Addendum 1

Project: Lathrop Fire Station 31
Rehabilitation
Project No: 757-01-20
Date: 12/09/2020

From Architect: LDA Partners, Inc.
222 Central Court
Stockton, CA 95204

This Addendum forms a part of the Contract Documents and modifies the original issued ***November 16, 2020*** as noted below. Acknowledge receipt of this addendum in submittal of bid.

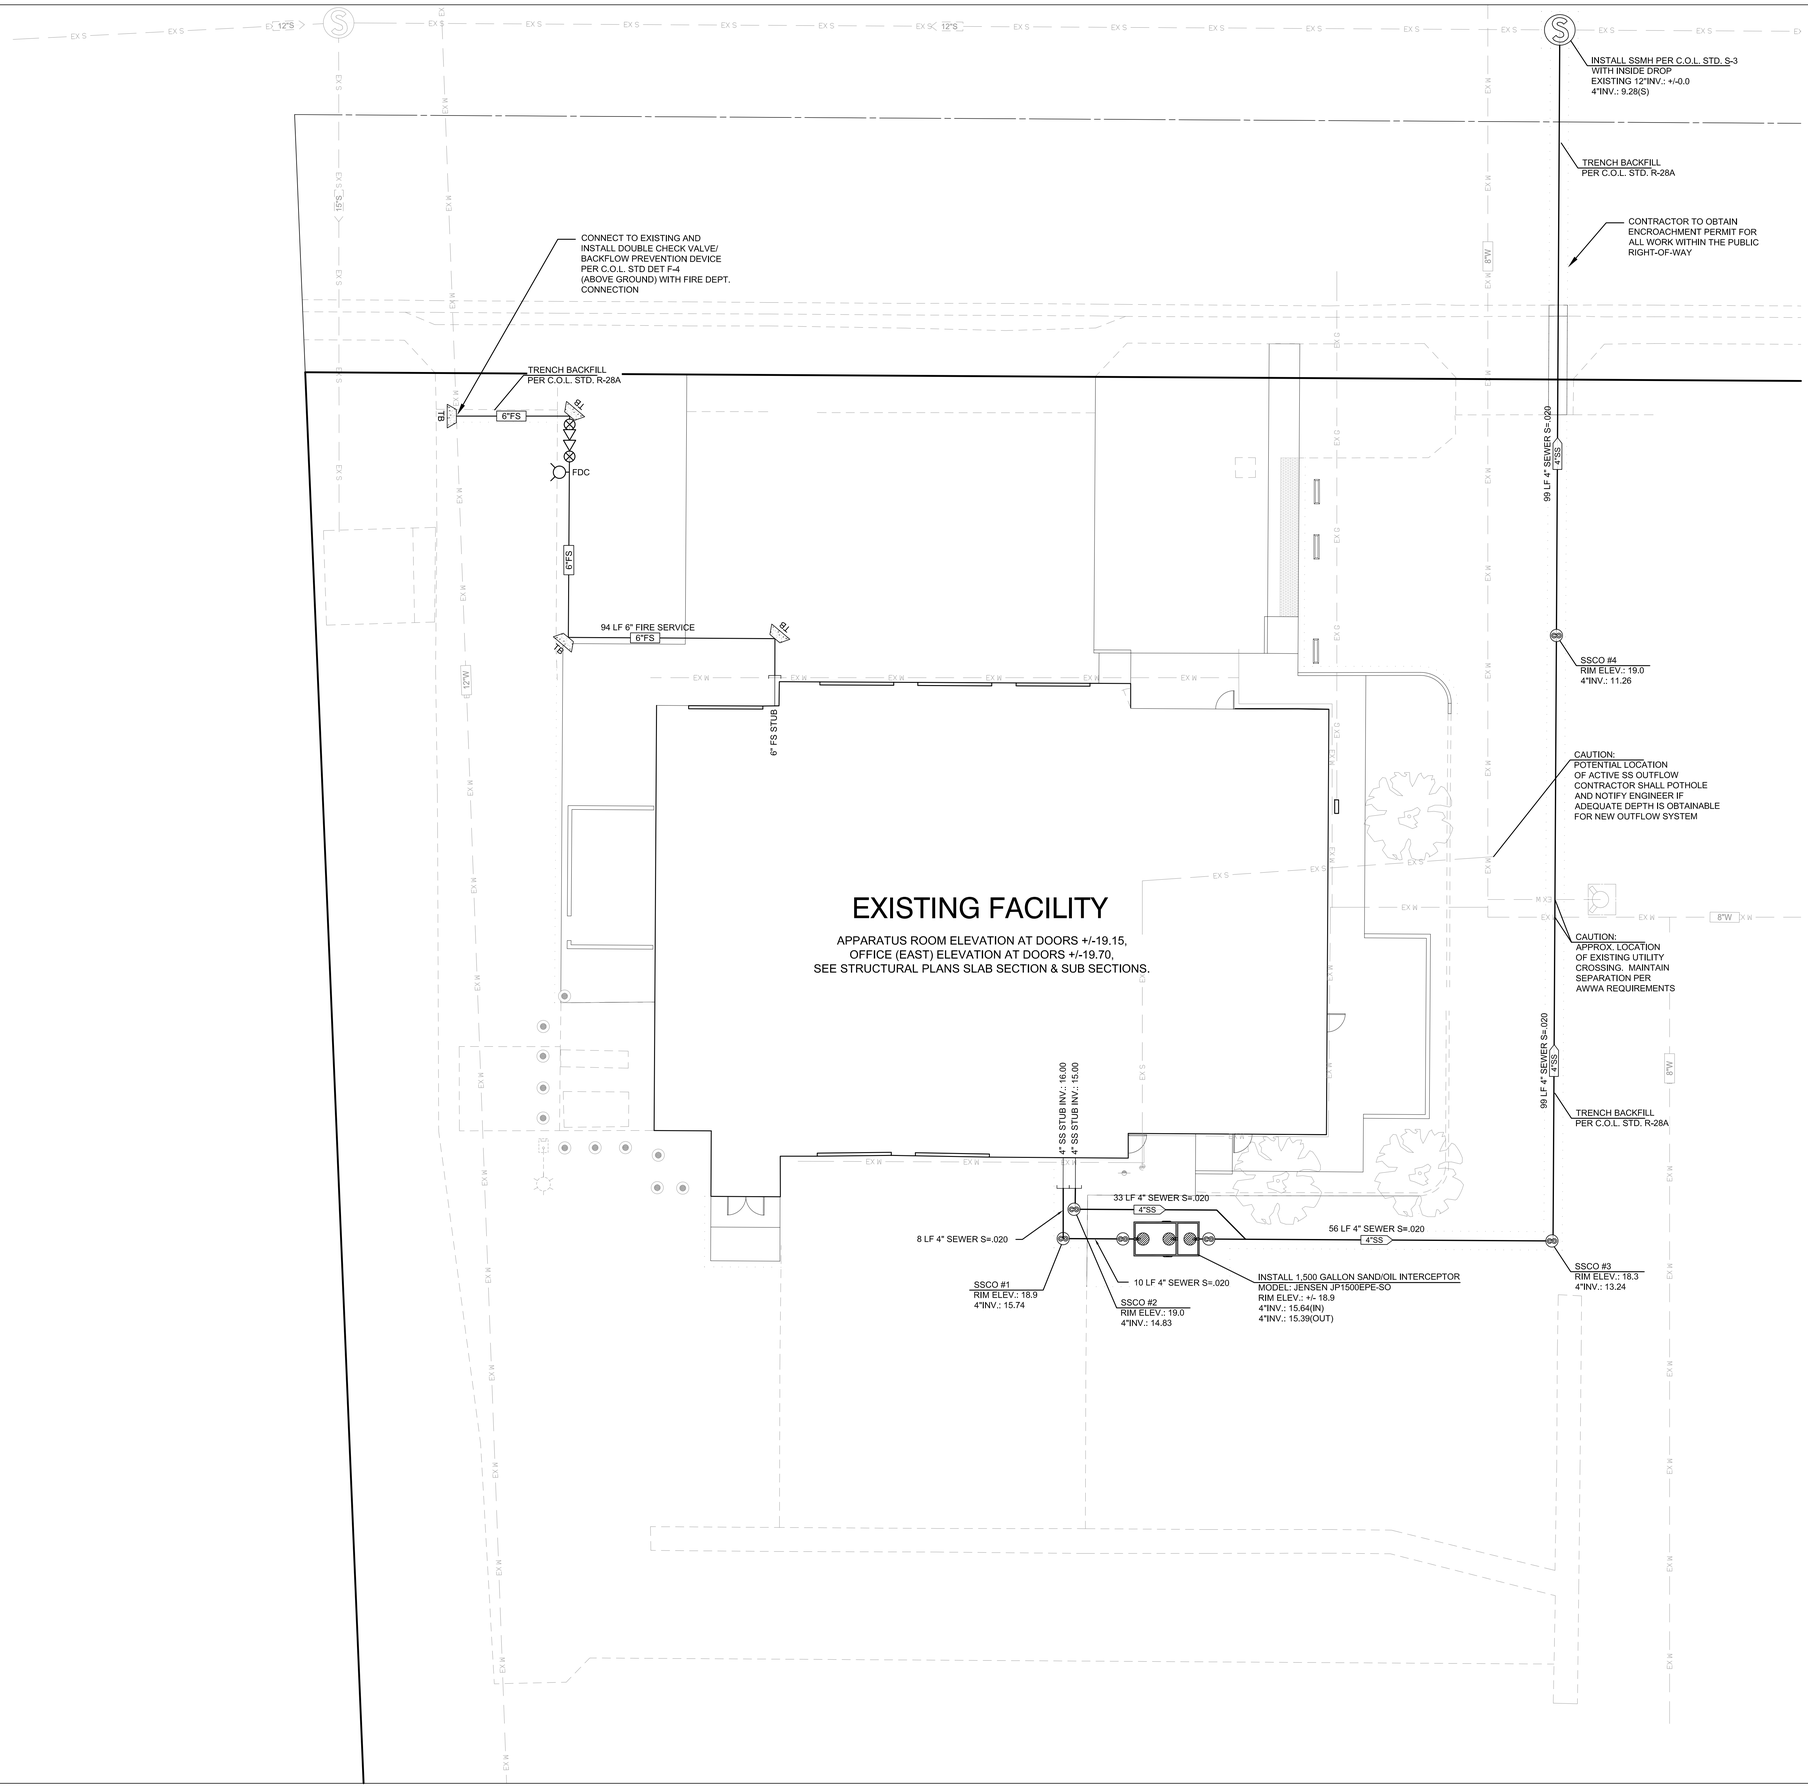
- Question: A new fire line will need to be tapped in from the street. The water main will be teed from the street to the riser. How will this be coordinated if the fire station is to be operational?
- Response: Refer to updated Civil Sheets.

1 A5.00 ROOF PLAN
1/4" = 1'-0"

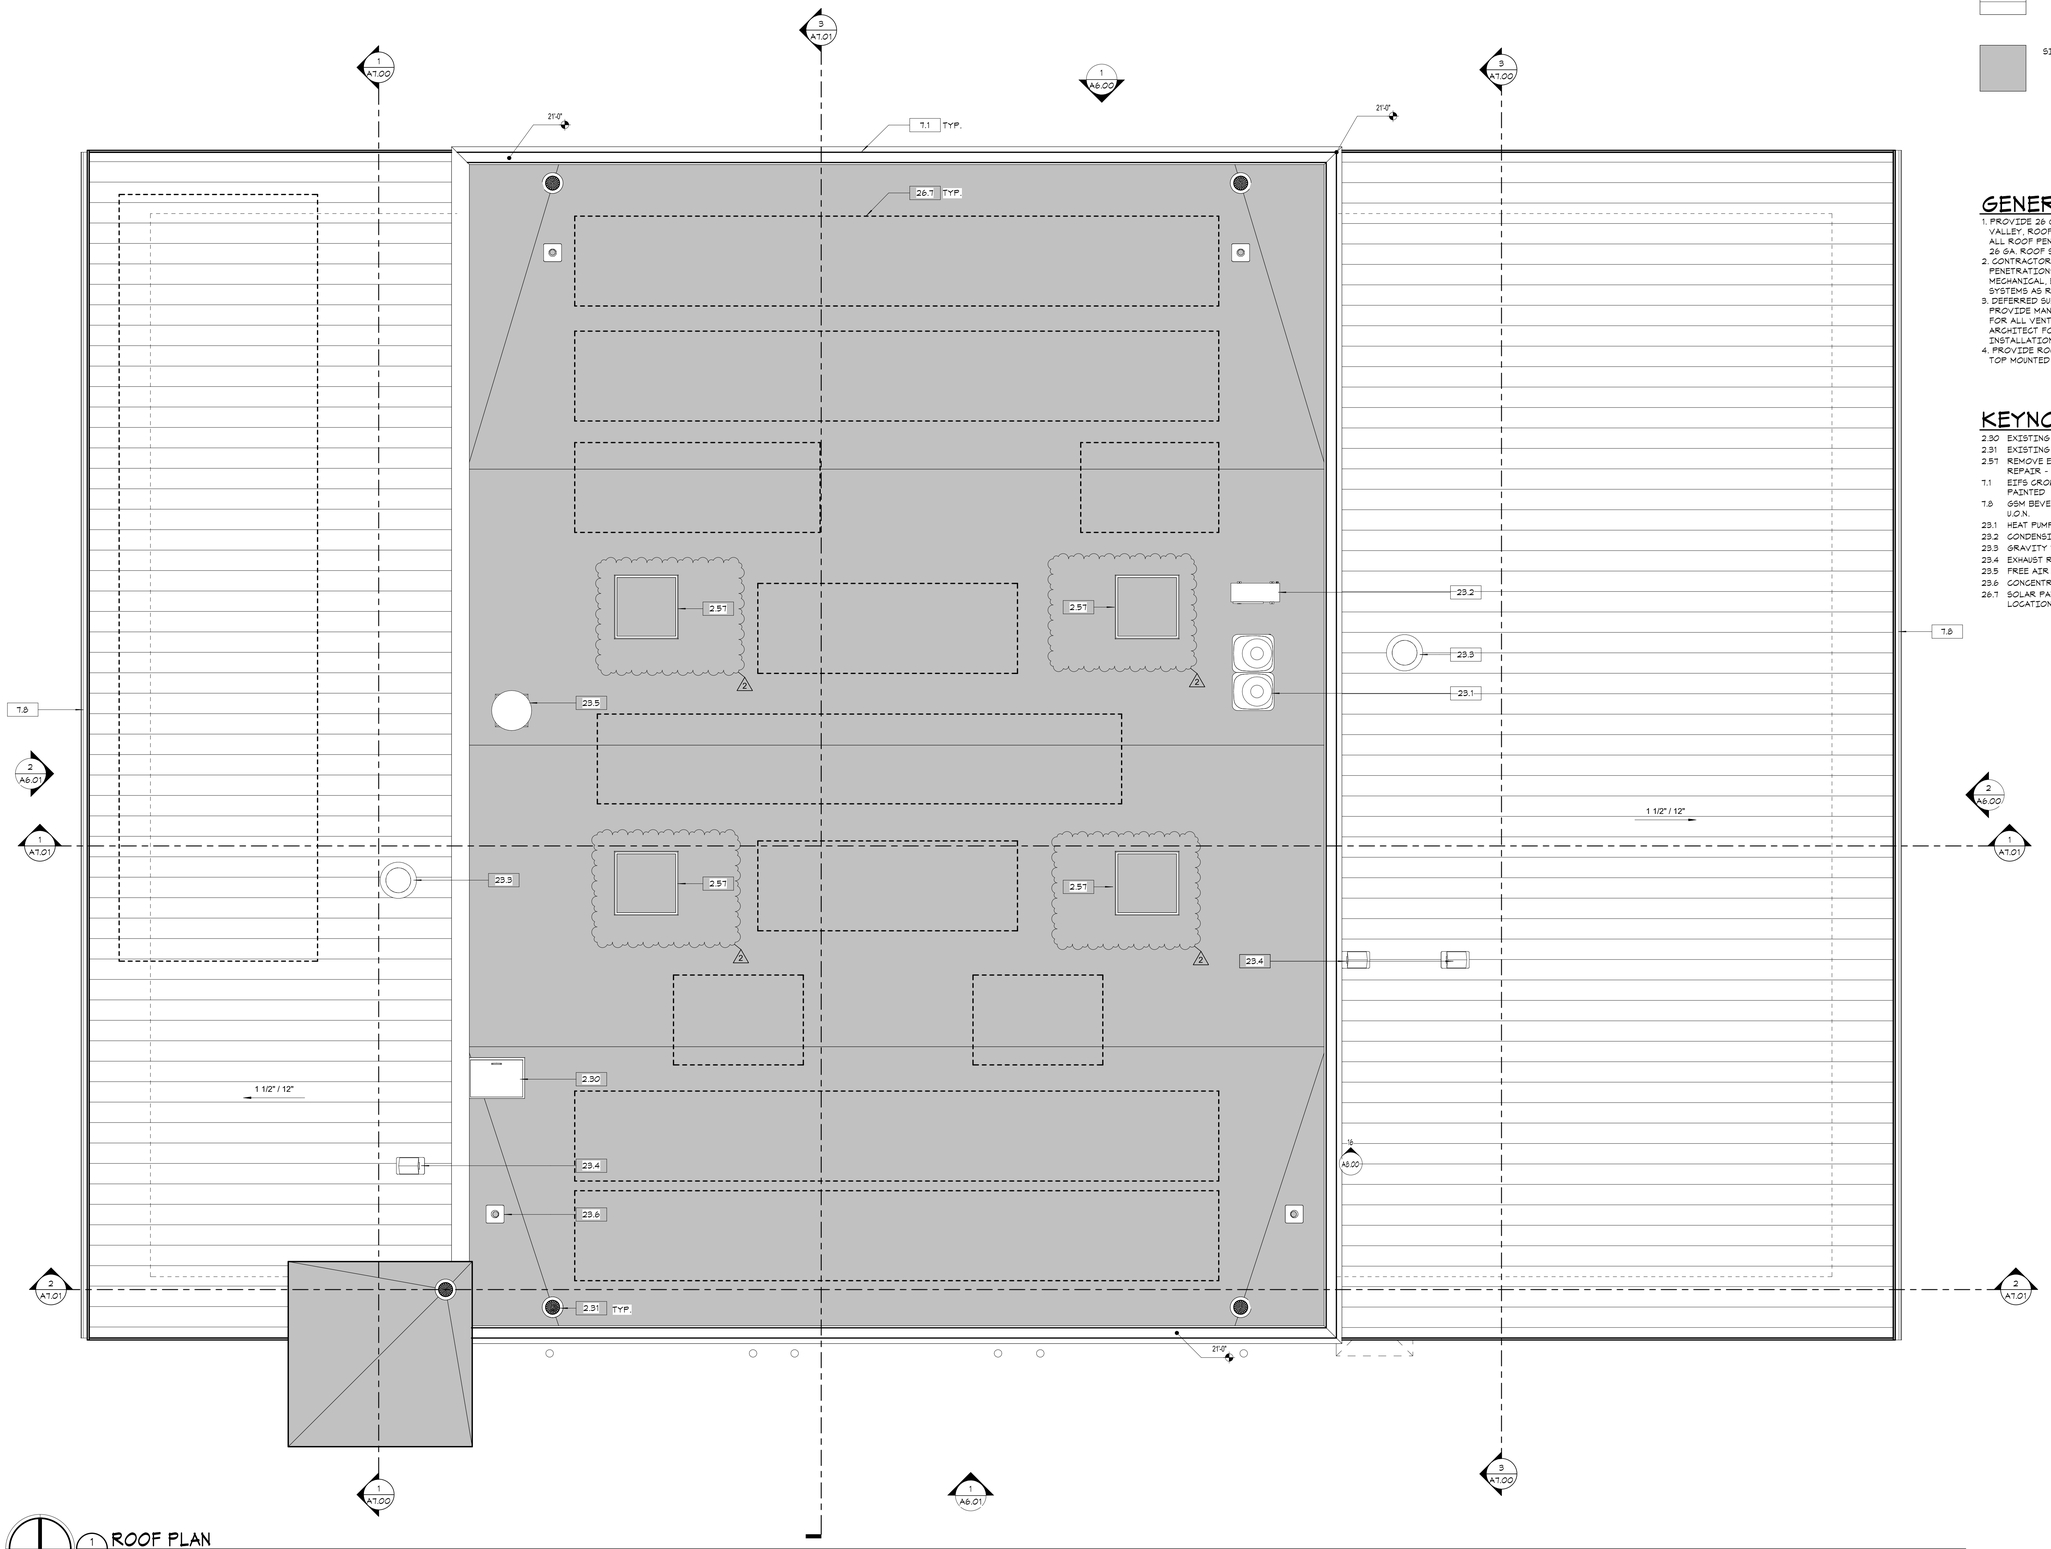
RFI#17

- Question: Per sheet A5.0, it calls out for single ply type roofing at the tower but yet on sheet A6.0 elevation, it calls out for metal panels roofing with pitch at the tower. Please clarify/confirm the type of roofing.
- Response: A5.00 indicates single ply roofing at the tower. A6.00 shows metal panels at the high part where (e) wood siding is being replaced.

2 A9.00 FINISH FLOOR PLAN
1/8" = 1'-0"

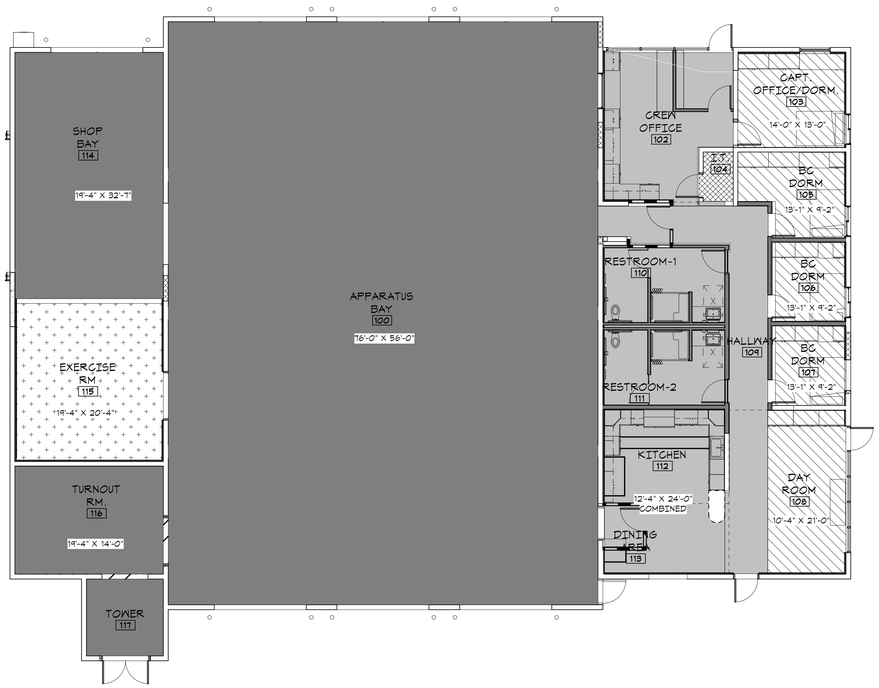
- Question: I am looking to bid on the Lathrop Manteca Fire Station #31 project. I would bid on the flooring and the ceramic tile but I don't see any specs on either. Will there be specs for those items issued in an addendum?
- Response: There is no ceramic tile on the project. Refer to sheet A9.0 for updated finish schedule.

1 PROPOSED LIGHTING PLAN

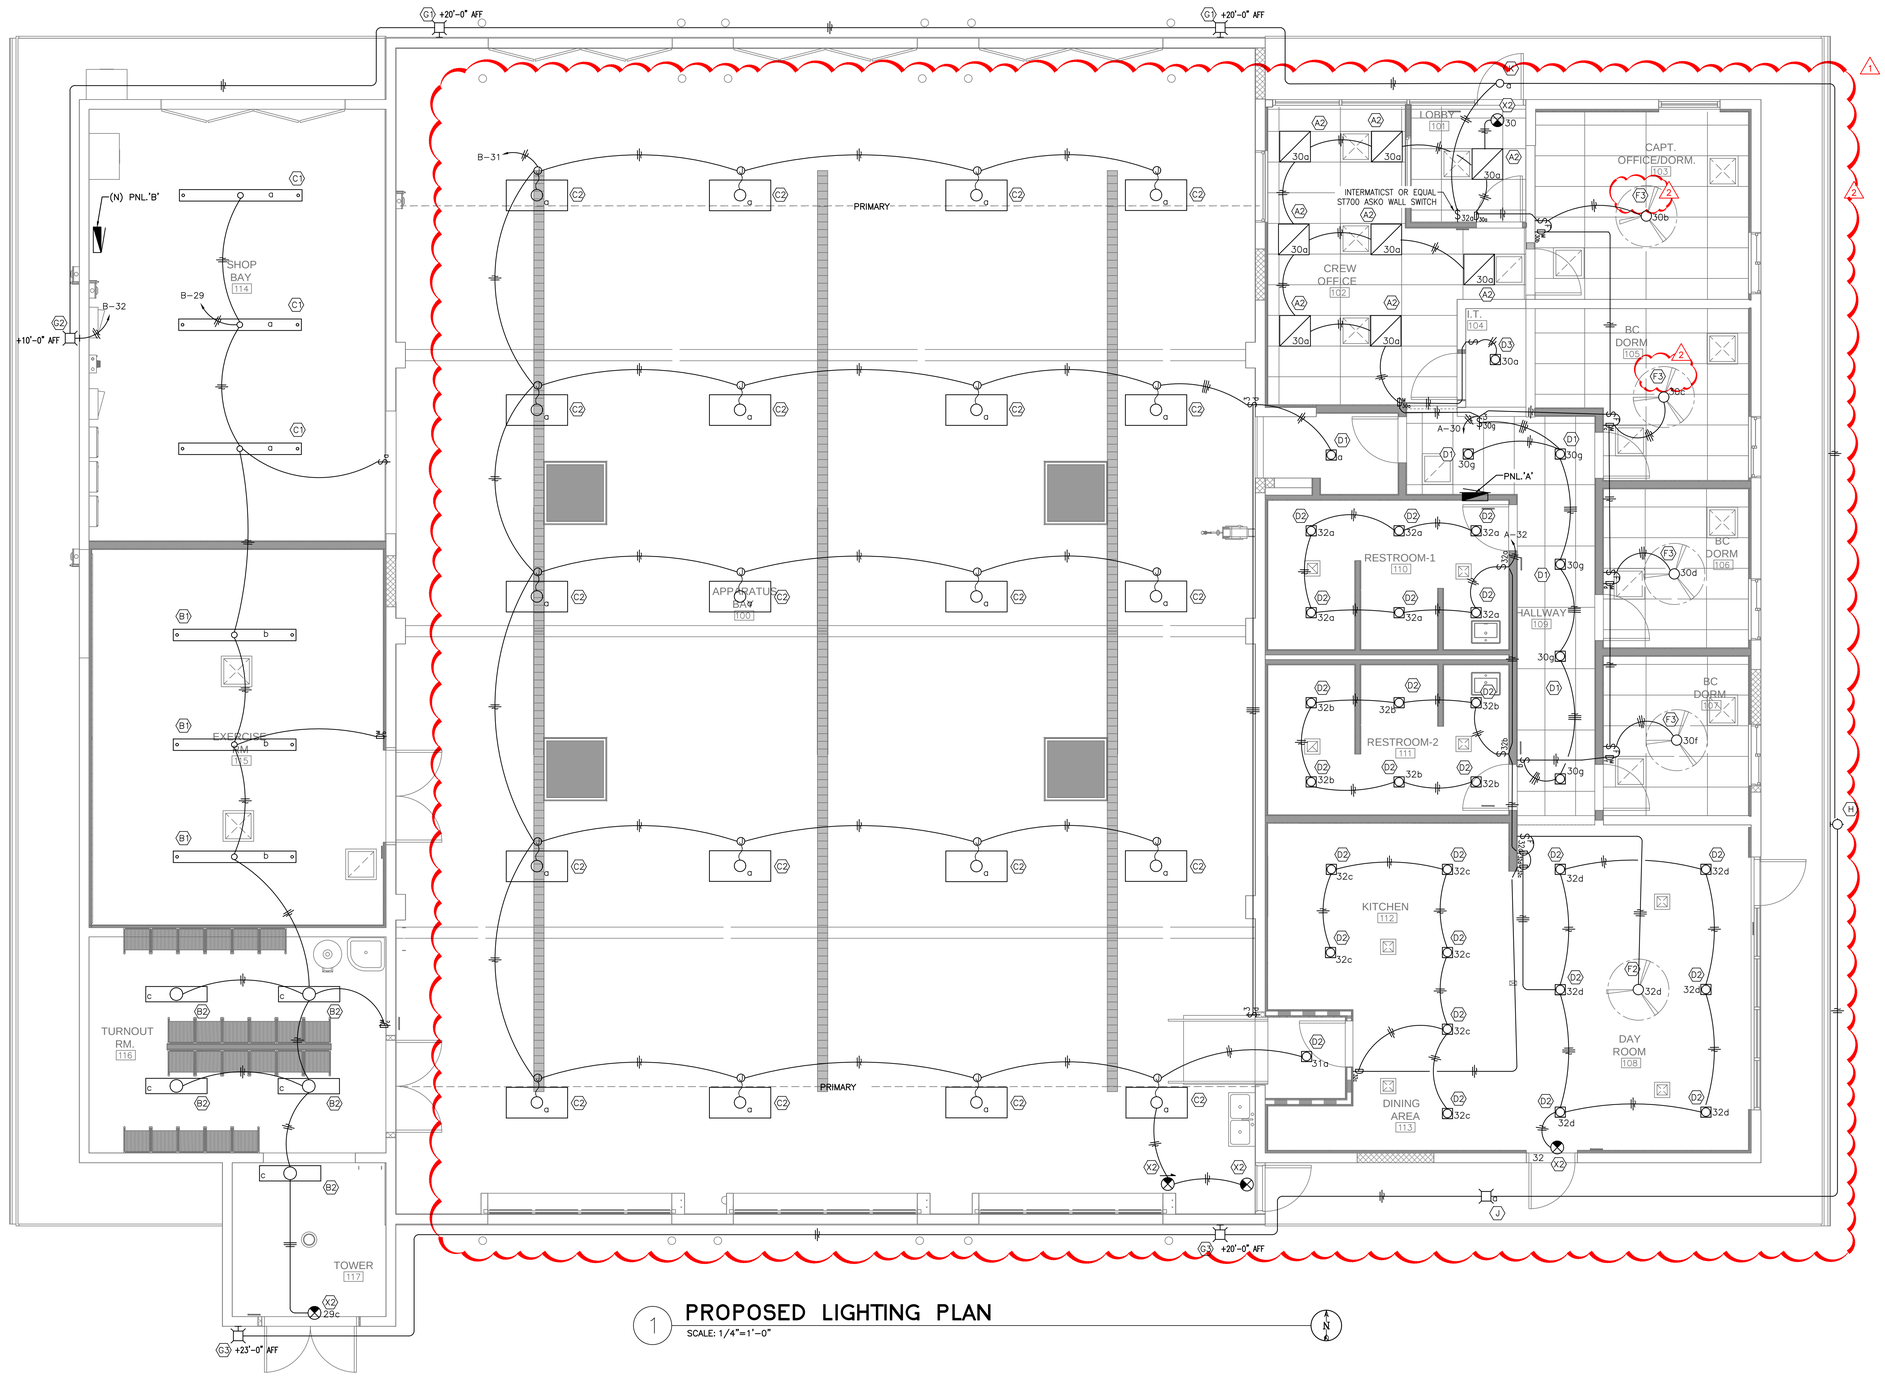
RFI#18

- Question: Please provide specification for fixture type "F4"
- Response: Reference to F4 have been revised to read F3 on Sheet E5.0.
